| Project | IEEE 802.16 Broadband Wireless Access Working Group < http://ieee802.org/16 > | |
| Title | CR on SDD Chapter 15: Load Balancing between Femtocell and Macrocell BSs | |
| Re: | Category: SDD comments / Area: Chapter 15 (Femtocell) “Comments on SDD 15 Femtocell” | |

Figure 1a. Traffic concentration in femto cells.

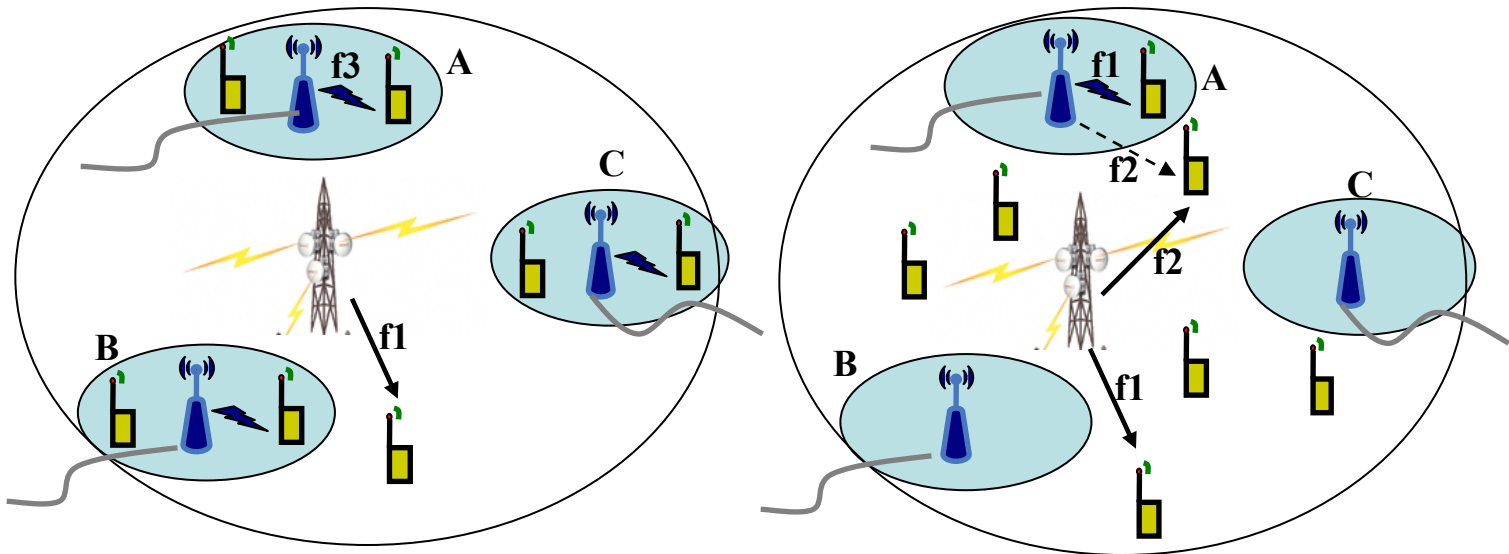
Current SDD text mentions that femto BS can coordinate with the macro BS or autonomously determine the resources to be used for its operation. Irrespective of which method is adopted, it does not currently provide provisions for load balancing between the femto and macro BS. Given the usage scenarios of femto cells in residences, enterprises, complexes, etc. it can be anticipated that the dynamics of traffic in these femto cells can vary significantly depending on the time of the day. For eg, one can expect more traffic from residential femto cells during the evenings. Given the large dynamic nature of load in these femto cells, it is very important for the service provider to coordinate the resources between macro and femto cells so that the resources are efficiently utilized contributing to better revenue. For eg. consider the scenario is Fig 1a and 1b. In Fig. 1a, the UE concentration is more in the femto cells compared to the macro, while in 1b it is the macro cell where traffic is concentrated. Using the same allocation of resources for both the scenarios will lead to poor utilization of resources and hence performance. For the scenario is 1a, more resources must be allocated towards the femto cells, while for 1b more resources must be allocated to the macro cell.

15.x Load Management and Balancing

It is important to efficiently balance the load between the macro and femto BS and adapt them to network dynamics to optimize capacity and QoS. To achieve this, some traffic performance metric (load, utility, etc.) can be periodically collected from the macro and femto BS to decide on the amount of resources that can be used by the macro, micro and the femto BS. How the macro and femto BS decide to use these resources in a distributed manner is not within the scope of this document. The periodicity (semi-static nature) of such information collection could also be implementation dependent.
